D1101968_aLIGO_OMC_Optical_Prisms, PART PDM REV: X-001, DRAWING PDM REV: X-000

CALIFORNIA INSTITUTE OF TECHNOLOGY MASSACHUSETTS INSTITUTE OF TECHNOLOGY		PART NAME aLIGO OMC tombstone	
SYSTEM ADVANCED LIGO	SUB-SYSTEM ISC	DESIGNER SWALDMAN	DATE 30 Oct 2011
NEXT ASSY D1101965	DRFTER SBARNUM	CHECKER SWALDMAN	DATE 15 Nov 2011
	APPROVAL PFRITCHEL		DATE Nov 2011

SIZE	DWG. NO.	REV.
B	D1101968	v3
SCALE: 3:1	PROJECTION:	SHEET 1 OF 1

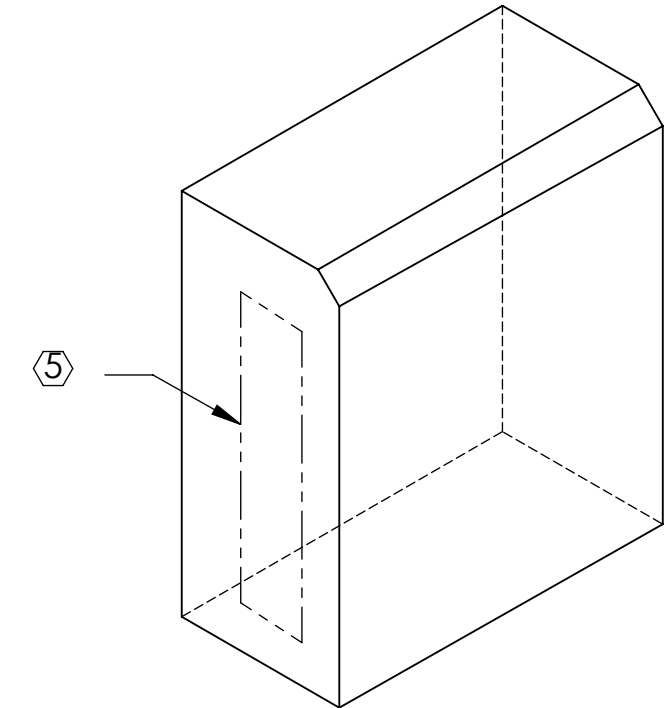
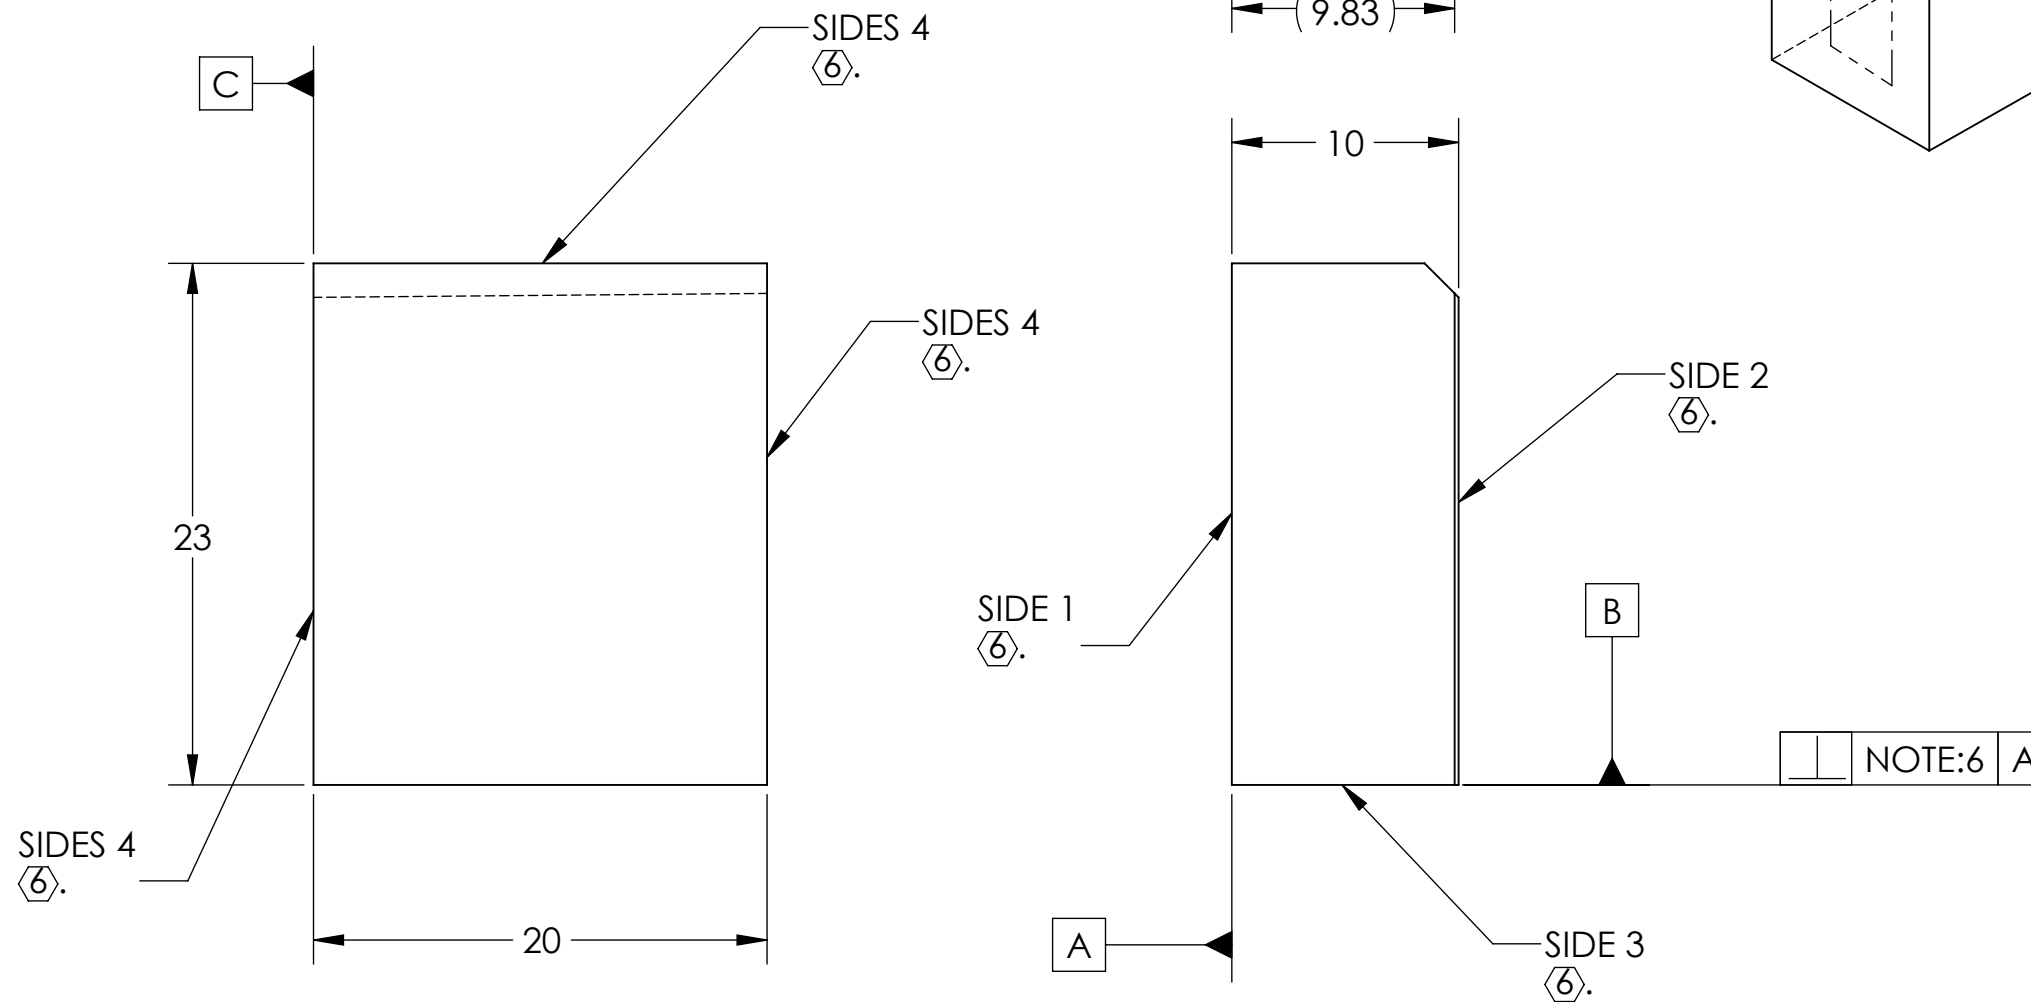
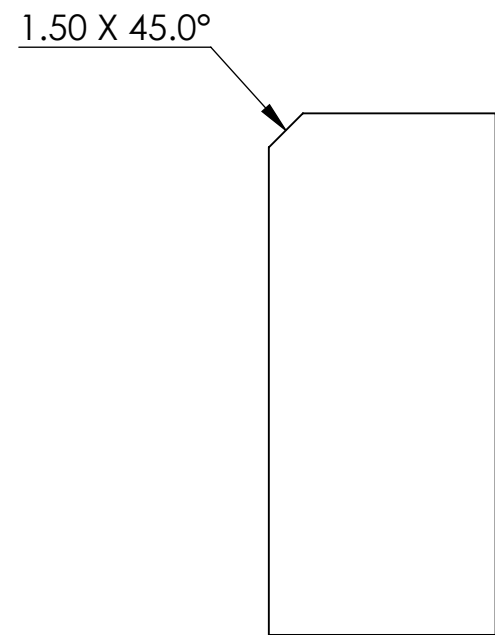
Redline Appert 20221108

For A+ fabrication, relevant substrate specification is E2000139 and relevant coating specification is E2000017.

Per the notation of the SOW E2000150:

- Type -1A is a High Reflectivity, Input/Output coupler (flat cavity mirror).
- Type -1B is a 50/50 Beamsplitter.
